NLT-PP-5584

October 1st, 2015

**NLT Product Change Notice**  
**PCN Tracking Number: NLT-PP-5584**  
**(Subjected products are revised from NLT-PP-5461)**

**5. Packing image**

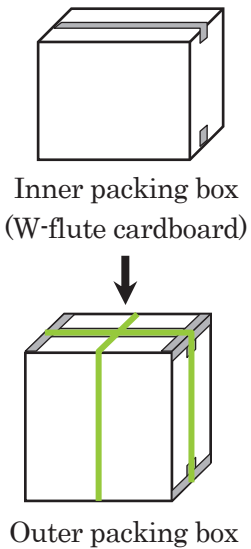
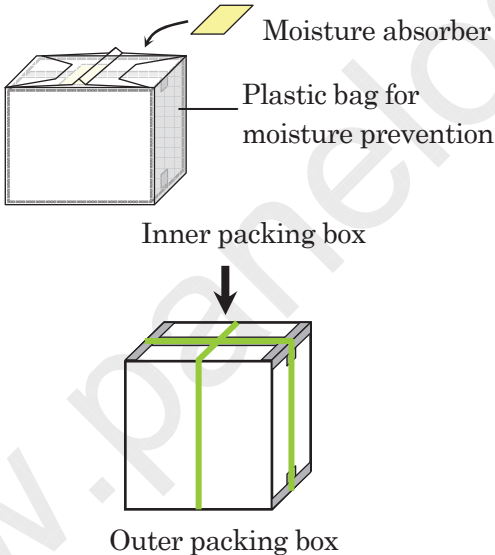
Item	Description of the change
Outer packing box for aircraft transportation	It will be deleted. Please see "5. Packing image".

NLT confirmed that the inner packing box made of double flute (W-flute) cardboard could pass NLT's package drop test without the outer packing box.

Therefore NLT decided to delete the outer packing box for aircraft transportation.

Current	After change
Transportation by aircraft	 <p>Inner packing box (W-flute cardboard)</p> <p>Outer packing box</p>	 <p>Shipping only with the inner packing box (W-flute cardboard)</p>
Transportation by ship	 <p>Moisture absorber</p> <p>Plastic bag for moisture prevention</p> <p>Inner packing box</p> <p>Outer packing box</p>	<p>No change</p>
